WILD WOOD BEACH SUBDIVISION

Revised for the April 17th meeting:

APPLICATION NUMBER 9 DATE March 20, 2008

REQUEST Subdivision

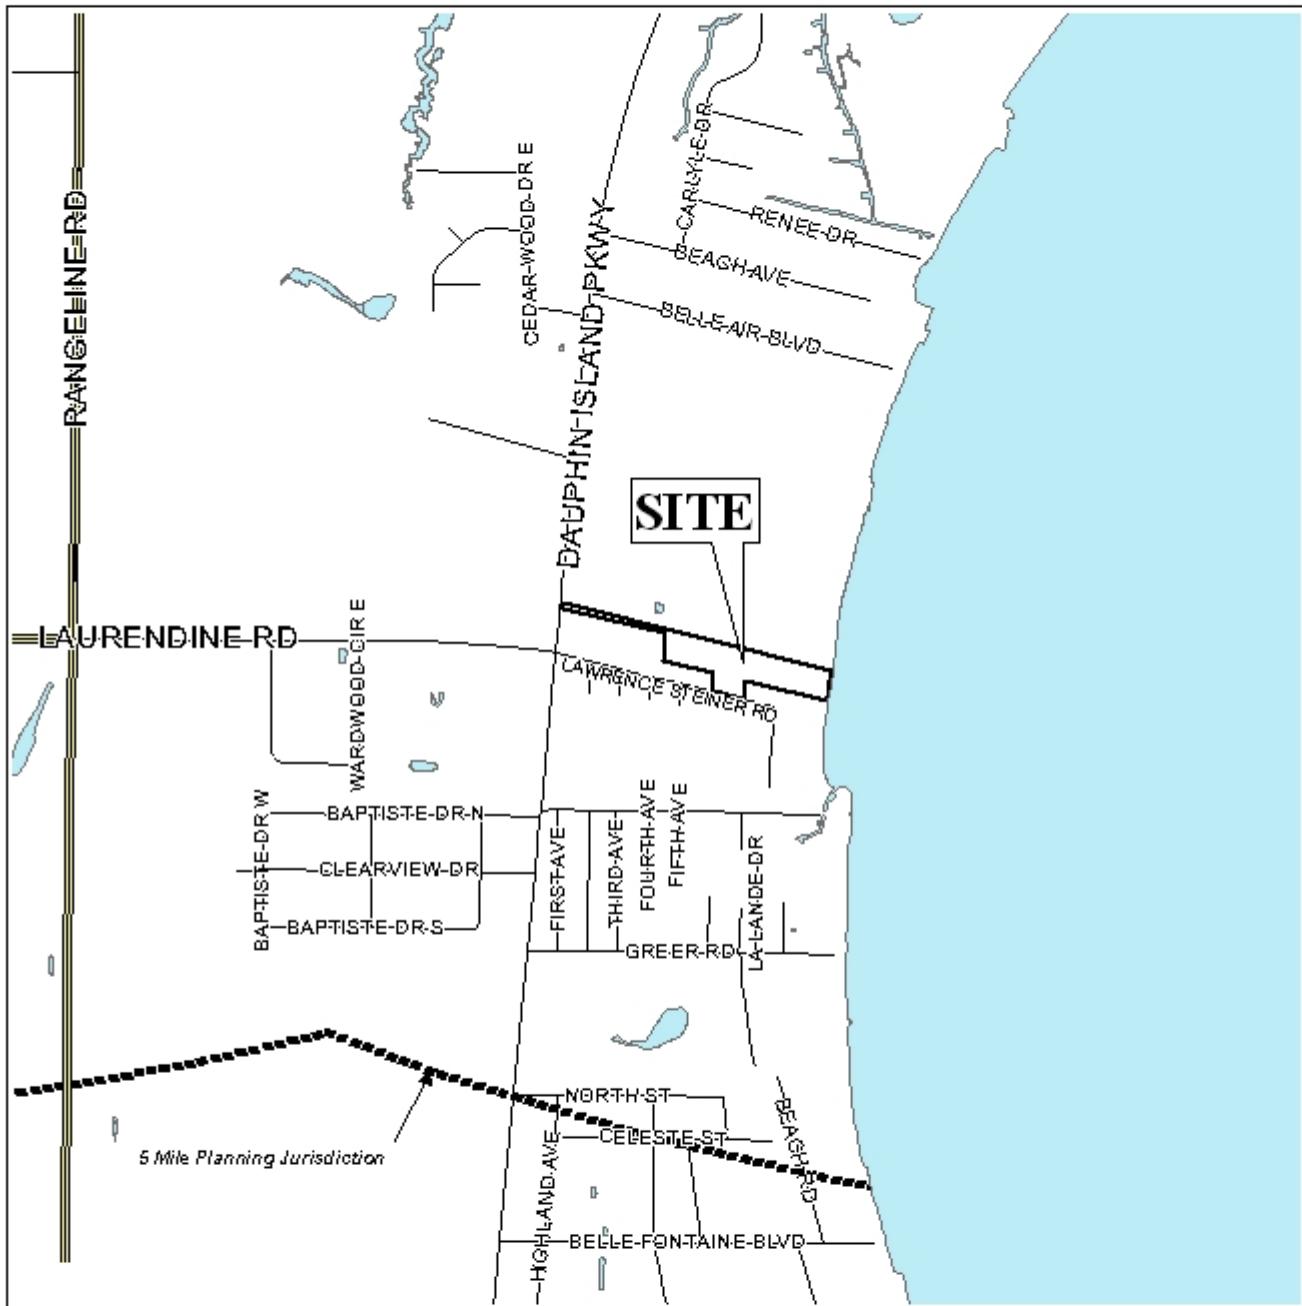
The site is bounded to the East by Mobile Bay. To the West, the proposed subdivision fronts Dauphin Island Parkway, with 80' of right-of-way. Dauphin Island Parkway is not a major street at this location; thus, it exceeds the minimum right-of-way requirement. To the South, the proposed subdivision fronts Lawrence Steiner Road, a minor street with 50' of right-of-way. The Subdivision Regulations require minor streets without curb and gutter to have a minimum 60' of right-of-way. The plat should be revised to provide a minimum 30' from the center line of Lawrence Steiner Road.

The applicant is proposing a five-lot family subdivision, with all lots being flag lots with frontage on Lawrence Steiner Road. Lots 1 - 4 will each have approximately 45' of frontage, while Lot 5 will have 25' of frontage. As unusual shapes and depths of lots are typical near Mobile Bay, a waiver of Sections V.D.1. and V.D.3 of the Subdivision Regulations may be appropriate. However if approved, a note should be placed on the final plat stating that no future subdivisions will be allowed until additional adequate frontage on a public street is provided. Furthermore, as a means of access management, a note should be placed on the final plat stating that the entire site is limited to two curb cuts to Lawrence Steiner Road, which will be shared by the five lots, and the existing curb cut to Dauphin Island Parkway, with the sizes, locations, and designs to be approved by County Engineering and conform to AASHTO standards.

A common area, also flag shaped and containing an existing dirt driveway, is illustrated on the plat with 25' of frontage on Dauphin Island Parkway. If approved, a note should be placed on the final plat stating that the maintenance of all common area(s) is the responsibility of the property owners.

Three ingress, egress, and utility easements are illustrated on the plat. If approved, a note should be placed on the final plat stating that no construction will be allowed within these easements.

The lots appear to meet the minimum size requirement for developments with individual wells and septic tanks (40,000 square feet per state code). However, if approved, it is requested that the applicant revise the preliminary plat to label the lots with their sizes in square feet, or provide a table on the plat with the same information.

Furthermore, the minimum building setback lines, along street frontages, are not illustrated on the plat. If approved, the plat should be revised to depict 25' minimum building setback lines from Dauphin Island Parkway and Lawrence Steiner Road. Since the subdivision consists of flag lots, the setback lines should be from where the "poles" meet the "flag" portions of each lot.

The applicant submitted the required information. With regard to Parcel #'s R023904020003021.003 & R023904020006001, the applicant submitted a letter from the owner of these properties stating that they do not wish to be a part of the subdivision process. The applicant also submitted a revised plat addressing lot square footages and setback lines.

With a waiver of Sections V.D.1. and V.D.3 of the Subdivision Regulations, this application is recommended for Tentative Approval subject to the following conditions:

- 1) dedication of a minimum 30' from the centerline of Lawrence Steiner Road;
- 2) placement of a note on the final plat stating that no future subdivisions of the site will be allowed until additional adequate frontage on a public street is provided;

- 3) placement of a note stating that the entire site is limited to two curb cuts to Lawrence Steiner Road, which will be shared by the five lots, and the existing curb cut to Dauphin Island Parkway, with the sizes, locations, and designs to be approved by County Engineering and conform to AASHTO standards;

- 4) placement of a note on the final plat stating that the maintenance of all common area(s) is the responsibility of the property owners;
- 5) placement of a note on the final plat stating that no construction will be allowed within the ingress, egress, and utility easements;
